**CITY OF PORTLAND, MAINE  
DEVELOPMENT REVIEW APPLICATION  
PLANNING DEPARTMENT PROCESSING FORM  
Planning Copy**

**Boy Scouts, New Building**  
Project Name/Description  
**131 - 131 Johnson Rd, Portland, Maine**  
Address of Proposed Site  
**232 A005001**  
Assessor's Reference: Chart-Block-Lot

**From:** Jeffrey Preble <jpreble@dufresne-henry.com>  
**To:** "jspence@ci.portland.me.us" <jspence@ci.portland...>  
**Date:** Sun, Jul 8, 2001 10:27 AM  
**Subject:** Boy Scout Review

**TO:** Chair Caron and Members of the Portland Planning Board  
**FROM:** Jonathan Spence, Planner  
**DATE:** July 10, 2001  
**SUBJECT:** Boy Scouts of America, Pine Tree Council Headquarters, 131 Johnson Road

SHEET TITLE  
**LANDSCAPE PLAN**

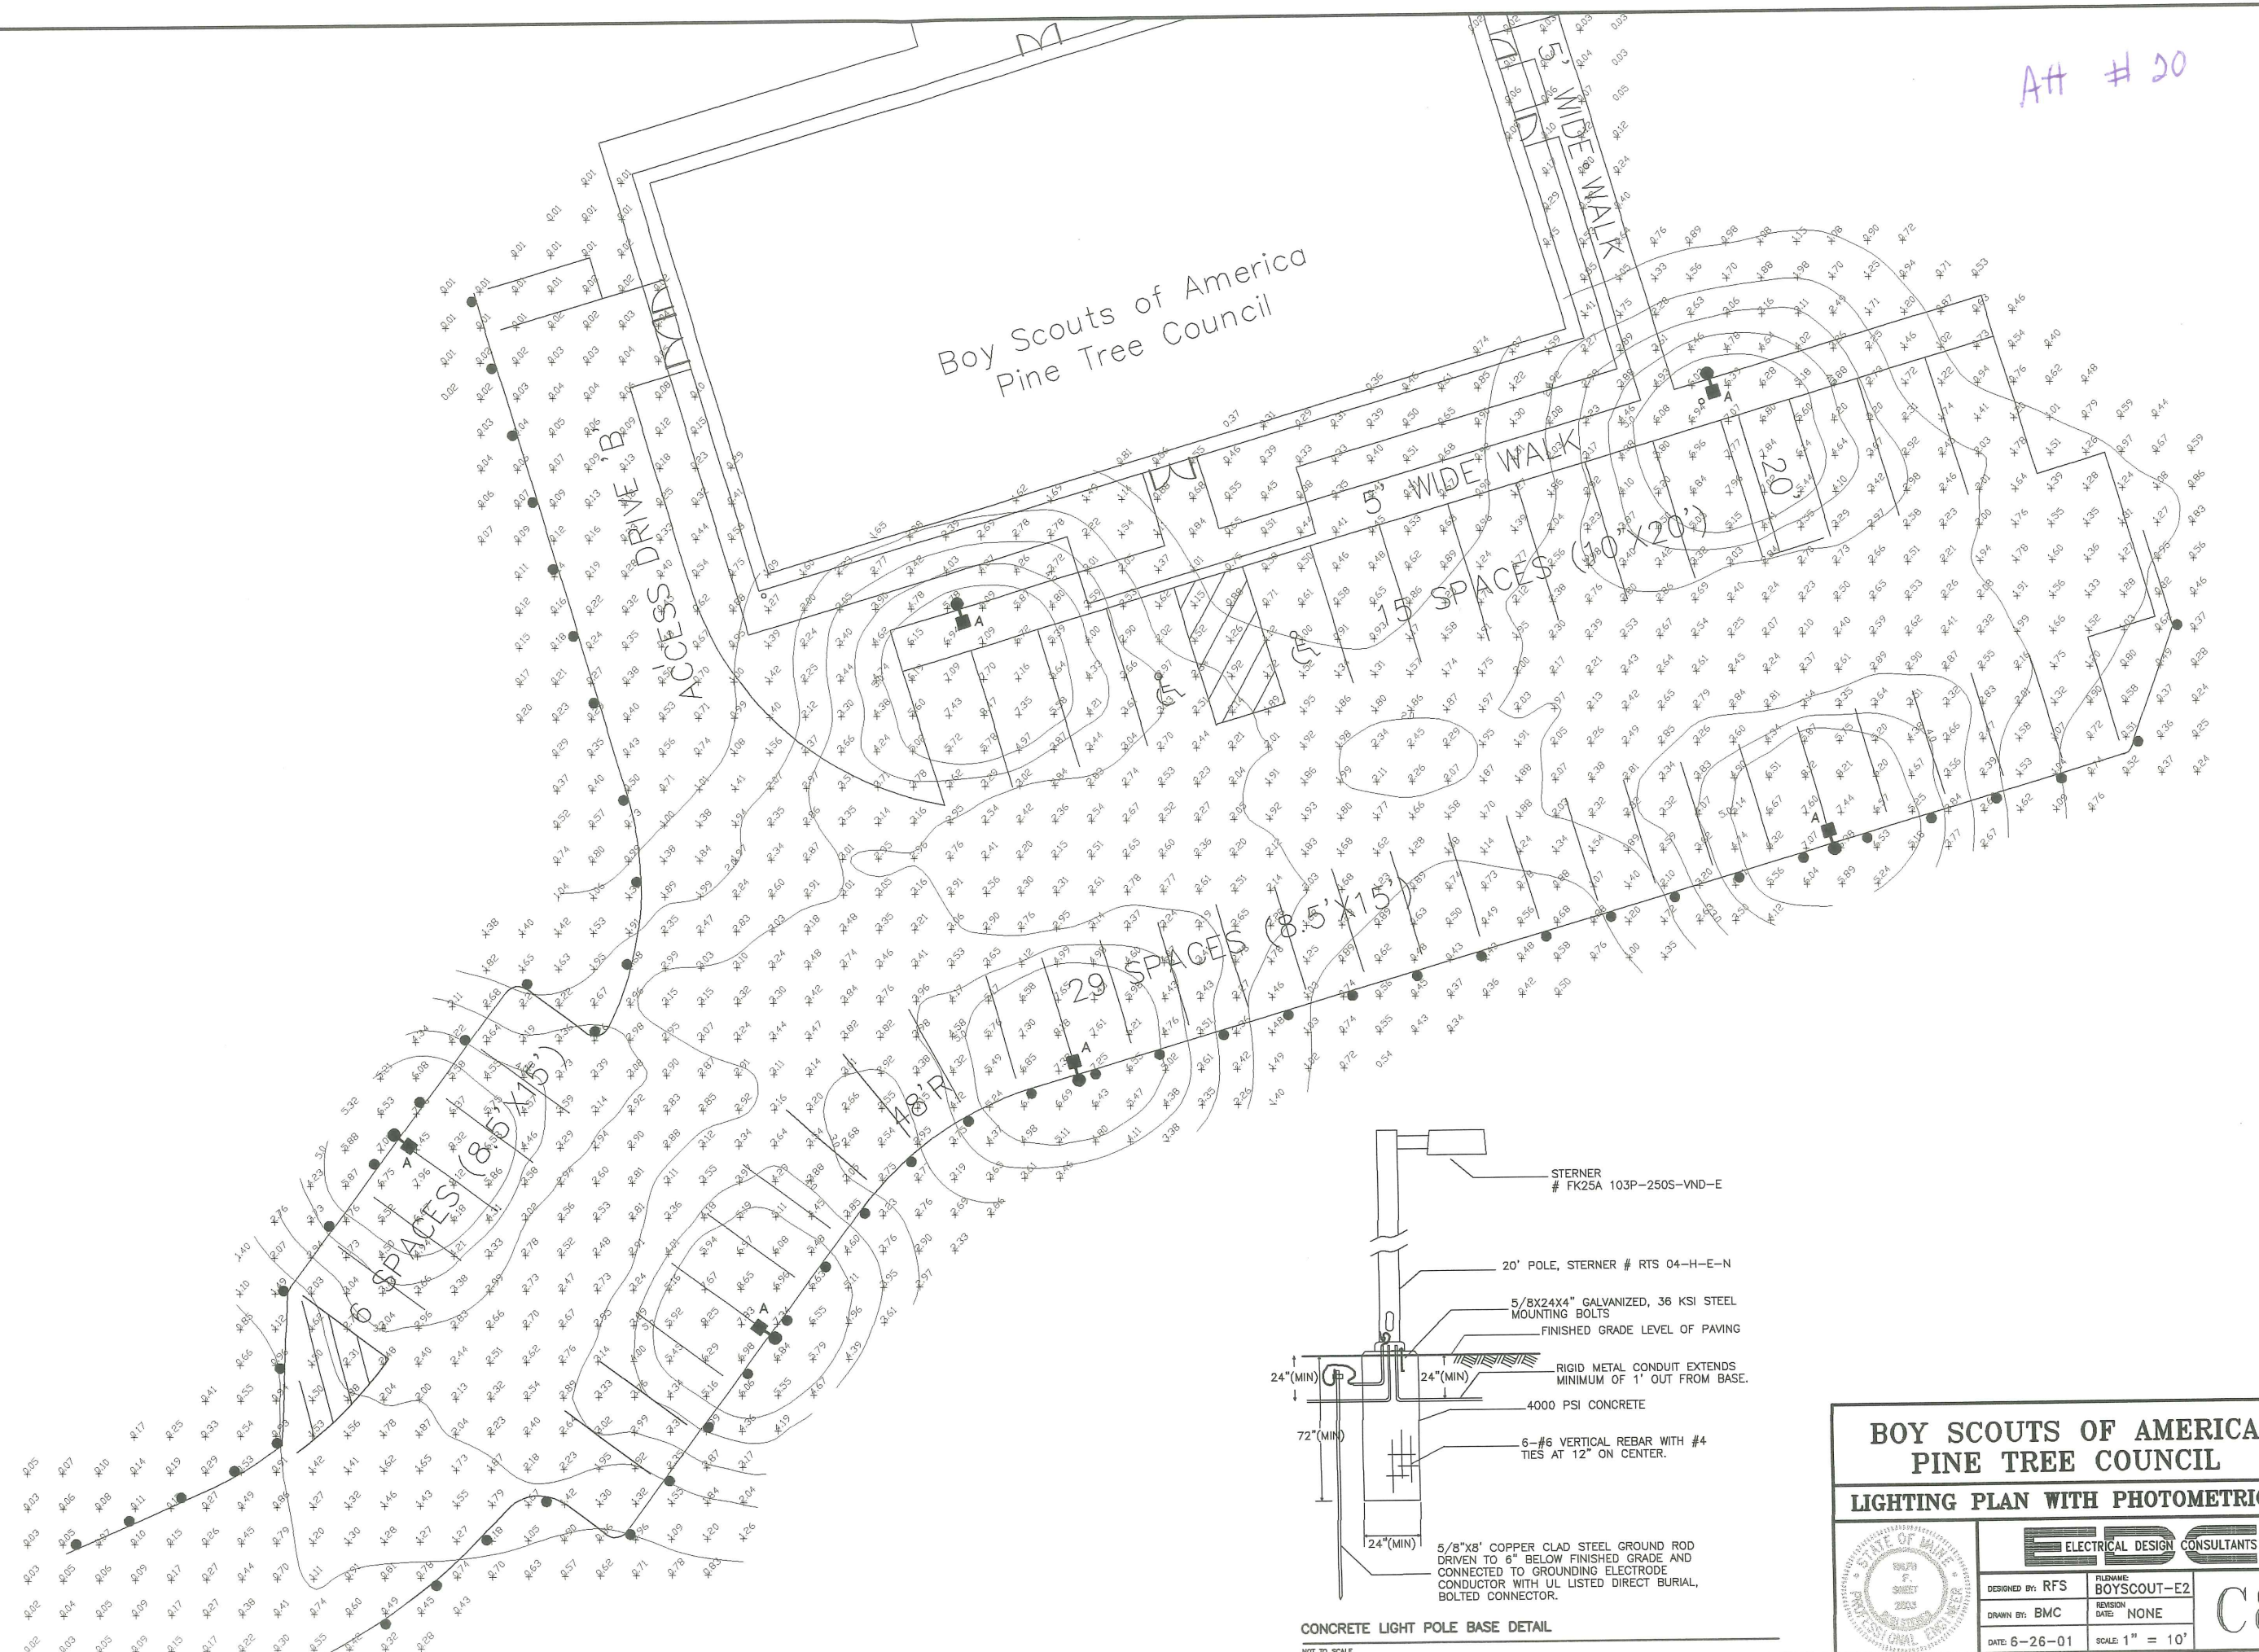
A landscaping plan has been added to the plan set. However, it does not contain alot of information or plantings.

The applicant has proposed four 6' high Arborvitae to be planted at the end of access drive "B". (See attachment 19). Staff encourages that applicant to utilize the full site to produce a landscape plan that includes native species to complement and enhance the property and its new use. Staff sees the landscape plan as an opportunity for the applicant to demonstrate an ethic of

With Jeff Tarling's assistance, the applicant has presented a landscape plan of foundation plantings that include a mixture of junipers, blueberries and arborvitae (see attachment 25). Although this plan meets the requirements of the landscape standards, staff would encourage the applicant to further enhance the site's landscaping through appropriate, native-species based, Scout projects.

A landscape plan has been added to the revised plan set as Sheet C7.

**LIGHTING PLAN WITH PHOTOMETRICS**

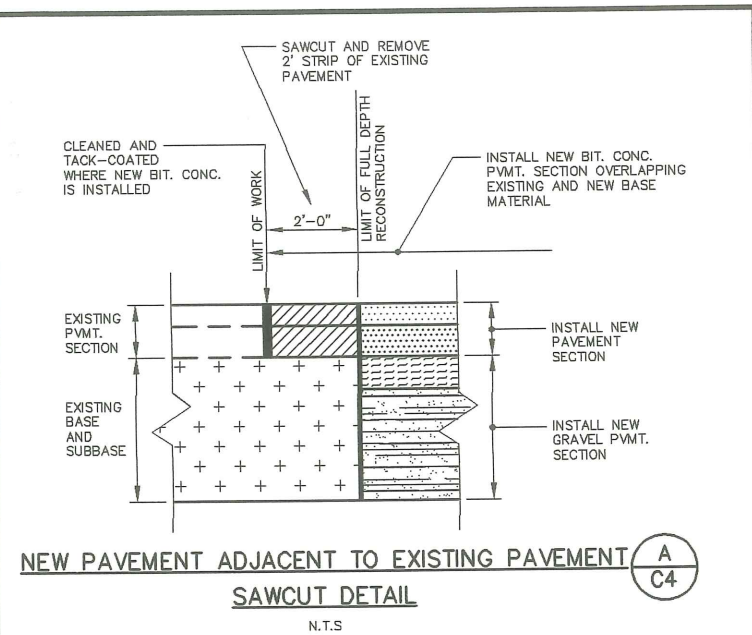
The lighting plan provided does not provide any data from the parking spaces and the intersection at Johnson Road. We did not receive any of the catalog data on the lighting fixtures.

A lighting plan showing photometrics has been added to the revised plan set as Sheet C8. Catalog cut for fixtures are also attached.

Details on exterior lighting have been added to the plan set. Photometrics are shown on Sheet C8 of the plan set. The proposed lot meets ANSI standards for lighting. Catalog cuts for proposed light fixtures are attached.

**GRANITE BLOCK WALL DETAIL**  
 N.T.S. (L) C4

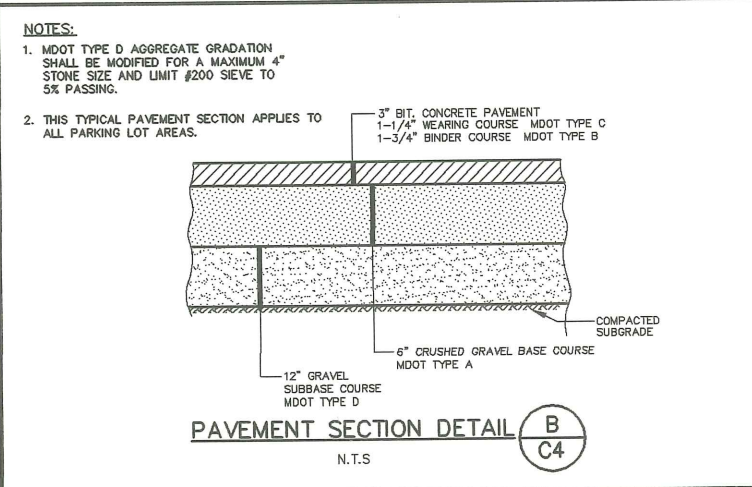
The preliminary granite wall detail is missing from our information.
